RE: Stormwater Peer Review (DRI-81-M3)
69 Beach Road
Tisbury, Massachusetts

Green Seal Environmental, LLC (GSE) is pleased to provide the Martha's Vineyard (MV) Commission the following peer review of stormwater related application materials as part of DRI-81-M3. The Applicant, Vineyard Wind, intends to construct a new 11,108 sf operation and maintenance facility (the "Project") to support its offshore wind turbine endeavor.

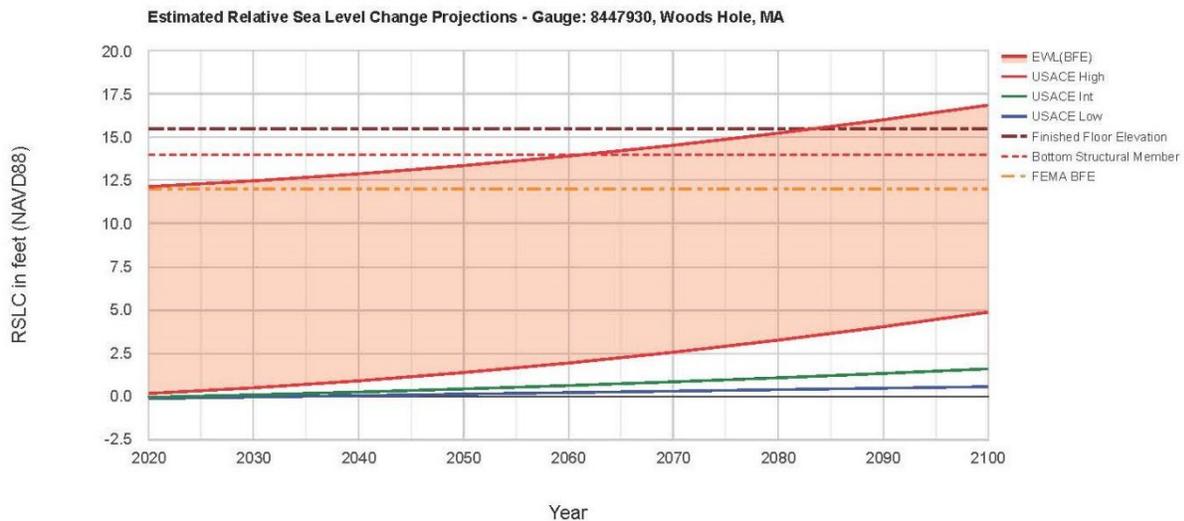
Utilizing Army Corps of Engineering on-line sea rise models, we evaluated the Project from a coastal resiliency point-of-view at the target years 2050 and 2070. The graph below indicates that a year the BFE will reach the bottom structural member in year 2054 and the finished floor in year 2078. Climate change models predict sea rise and subsequent base flood elevation rise may impact the proposed building structure in or about year 2054. The Army Corps model does not account for periodical storm surge which may intensify potential flood damage sooner than the 2054 date.
